DUKE POWER COMPANY

Re: RII:JPO
50-269, -270, -287
IE Bulletin 80-06

DUKE POWER COMPANY
OCONEE NUCLEAR STATION

Supplemental Response to IE Bulletin 80-06
Engineered Safety Feature (ESF) Reset Controls

SIMPLIFIED DIAGRAM OF CONTROLS
FOR HIGH PRESSURE INJECTION PUMP A

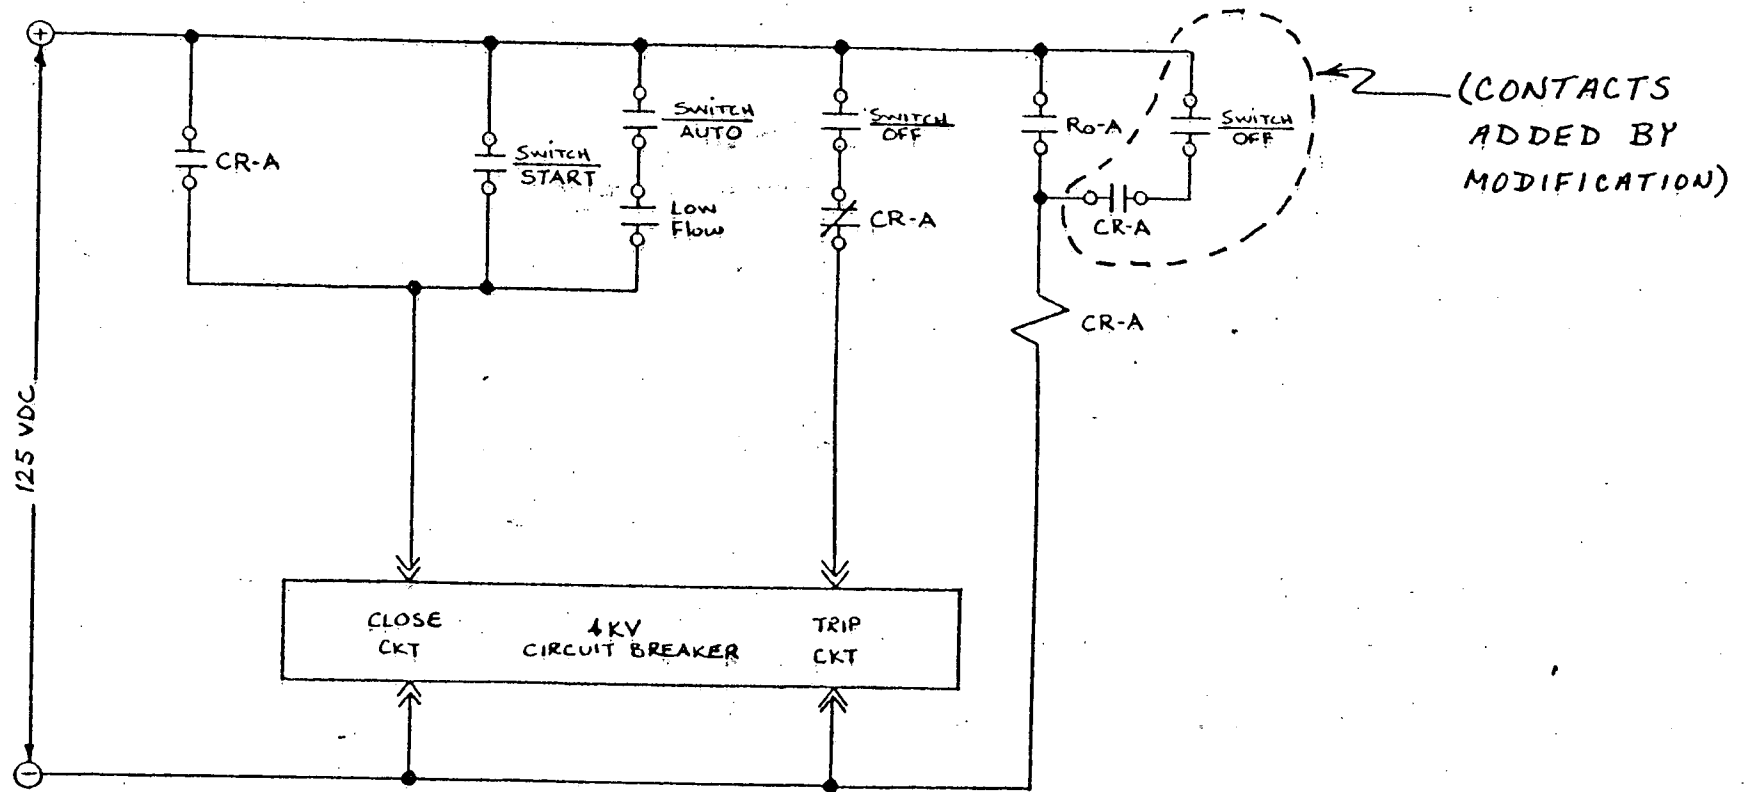
HPI pumps A or B may be either off, running, or in automatic control. For either pump an ES signal closes a contact (Ro) in the Engineered Safeguards Cabinet which energizes a control relay (CR) to provide a close signal and to block a trip signal to the pump circuit breaker. (For pump B controls an Ro contact and a associated control relay are provided for both trains of engineered safeguards). When the ES signal is reset one of the following conditions exist:

1. If the pump control switch is in RUN or AUTO positions, relay CR is deenergized but the pump continues to run because its circuit breaker has not been given a trip signal.
2. If the pump control switch is in OFF, relay CR is sealed-in by a contact from relay CR connected in series with a control switch contact that is closed when the switch is in the OFF position. In order to stop the pump, the operator must turn the control switch to either RUN or AUTO and back to OFF. (Appropriate instructions are provided to the operator adjacent to the control switch)

SIMPLIFIED DIAGRAM OF CONTROLS
FOR A PENETRATION ROOM EXHAUST FAN

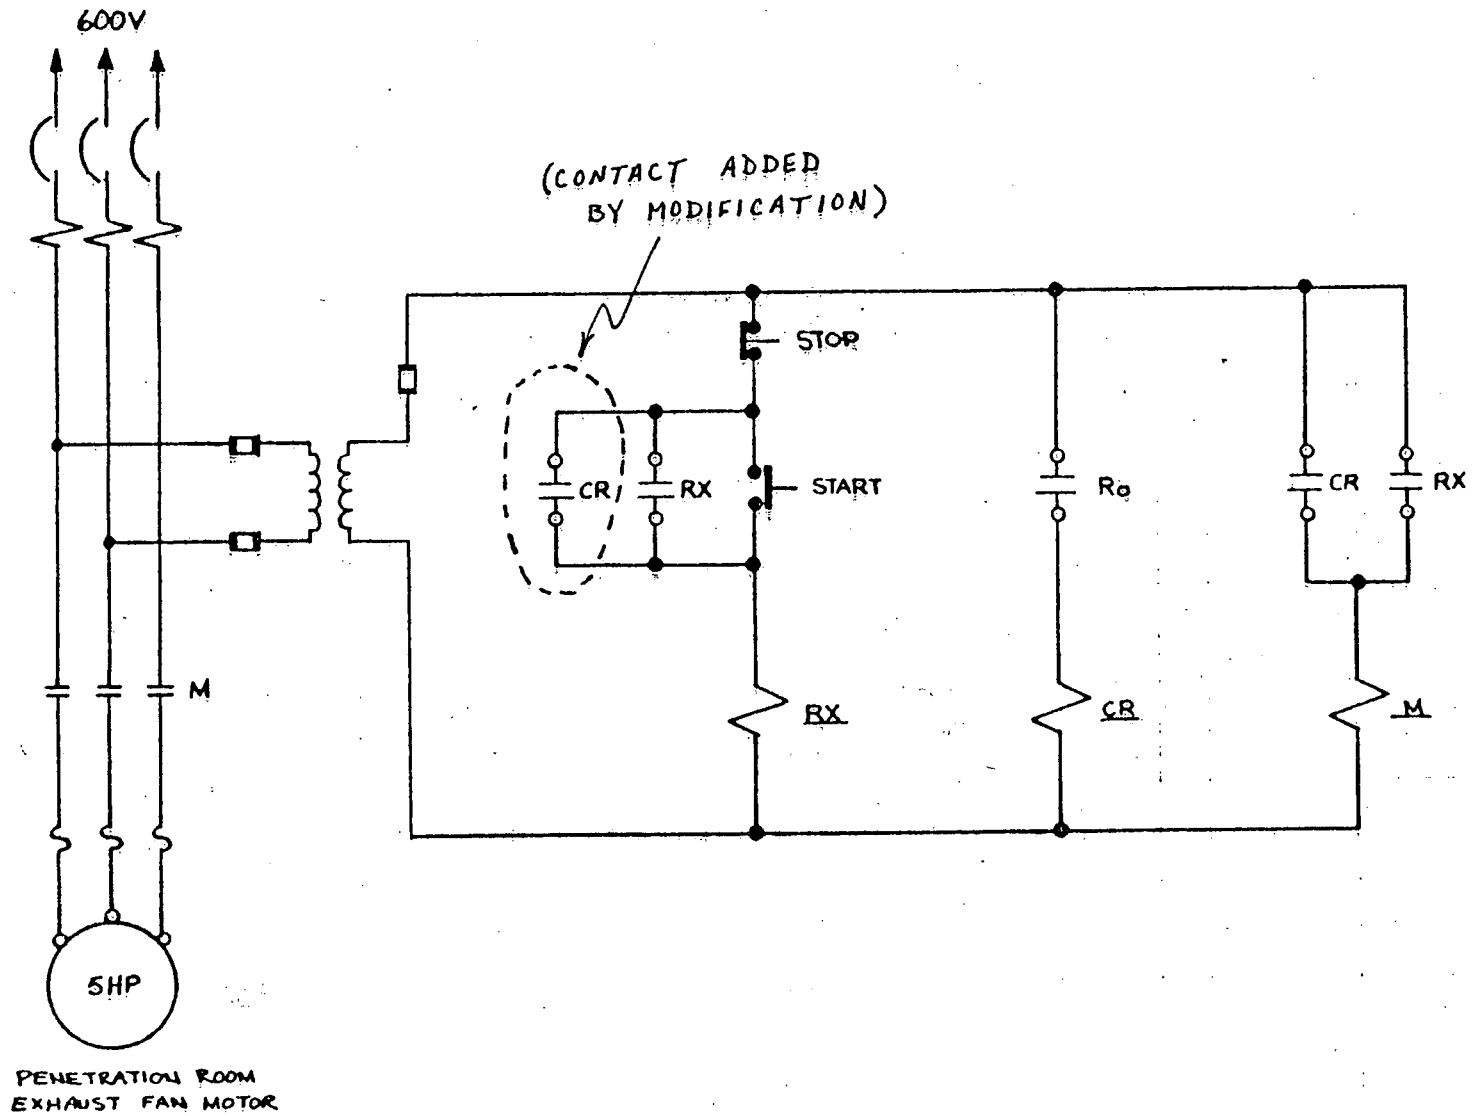
A penetration room exhaust fan is driven by a 600 volt motor that is controlled by a motor starter M coil. When the M coil is energized, its contacts close to provide power to the fan motor. The M coil may be energized to start the PR fan motor by either of two methods:

1. Pressing the START push-button momentarily closes a contact to energize auxiliary relay RX. Contacts from relay RX close to seal itself in and to energize the M coil. A momentary STOP push-button in series with relay RX is provided to deenergize RX thus deenergizing the M coil and the motor.
2. An engineered safeguards contact (Ro) closes on an ES signal to energize a control relay (CR). Contacts from relay CR close to energize the M coil and to energize relay RX. Relay CR remains energized until the ES signal is reset, but the motor continues to run until the STOP push-button is operated because relay RX has sealed-in.

SIMPLIFIED DIAGRAM OF CONTROLS
FOR REACTOR BUILDING COOLING UNIT FAN A OR C

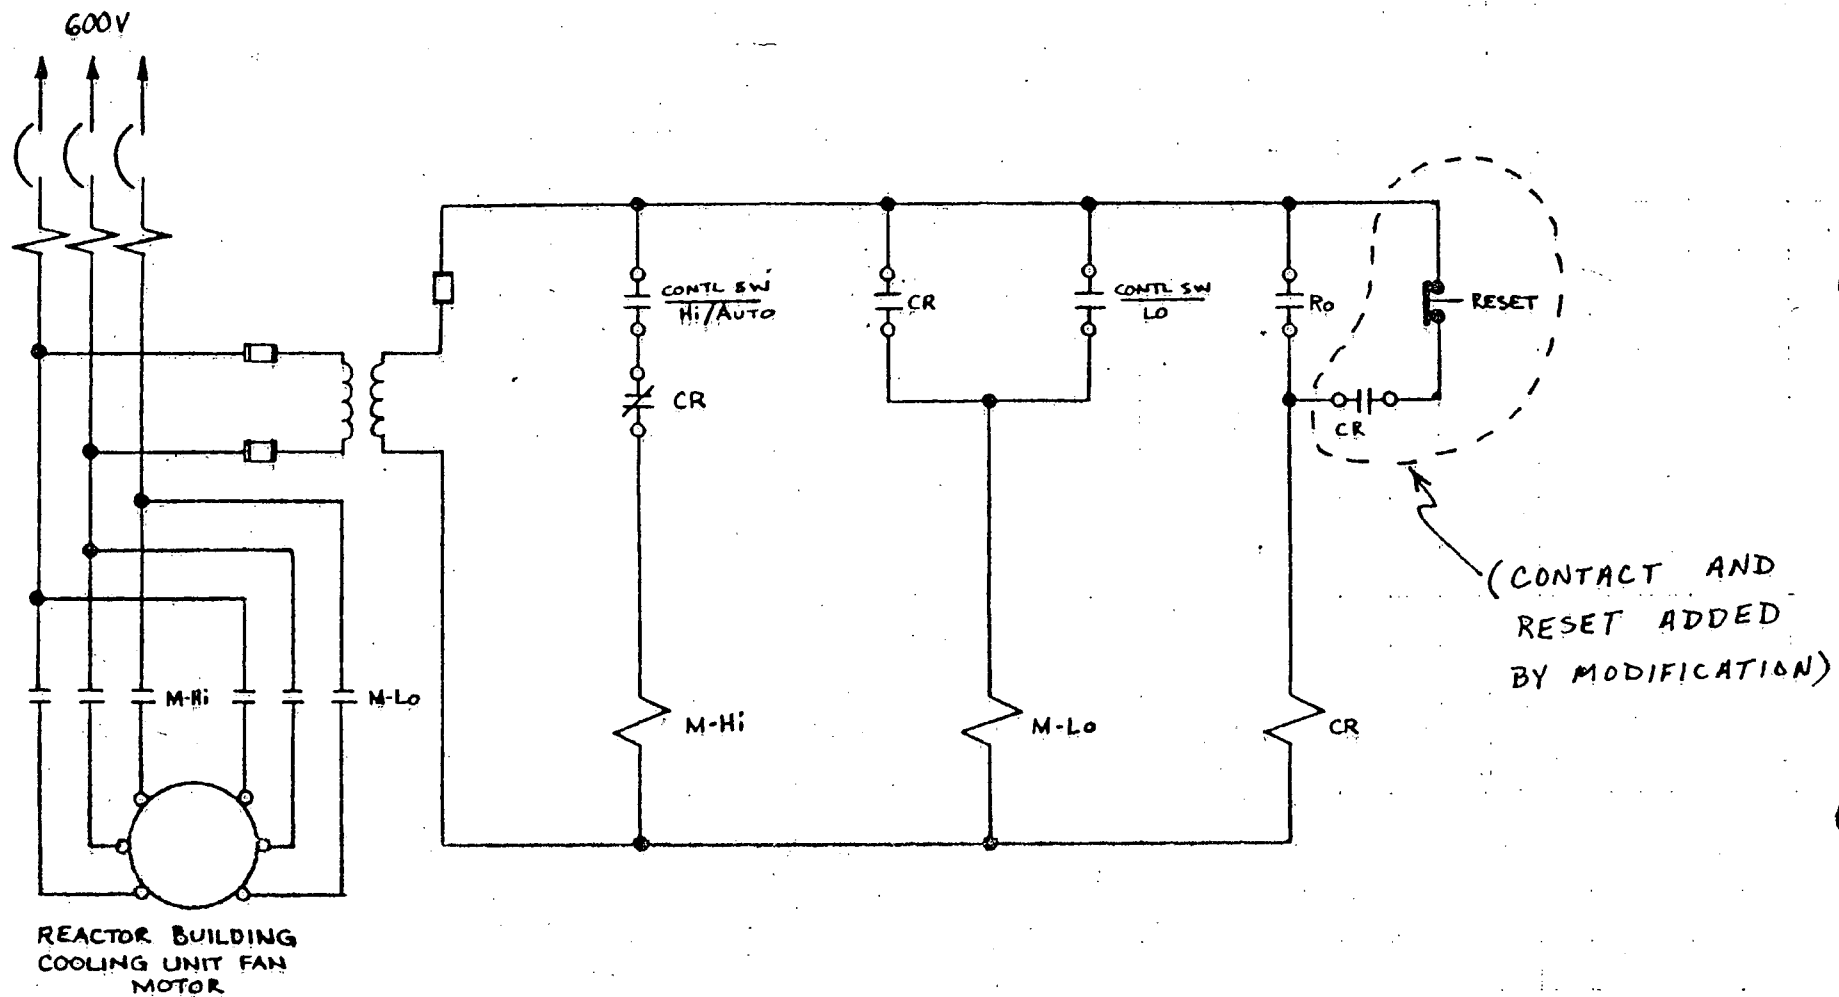
A reactor building cooling unit fan is driven by a two speed, 600 volt motor that is controlled by a two speed motor starter. An ES signal starts the fan motor by closing a contact (Ro) in the Engineered Safeguards Cabinet. Contact Ro energizes control relay CR which blocks high speed operation and initiates low speed operation of the fan motor. (For fan B an Ro contact and an associated control relay is provided for both trains of engineered safeguards). The control relays close contacts to seal themselves in thus maintaining the fan motor in low speed operation after the ES signals are reset. A reset push-button is provided for deenergizing the control relays to allow a return to normal operation.
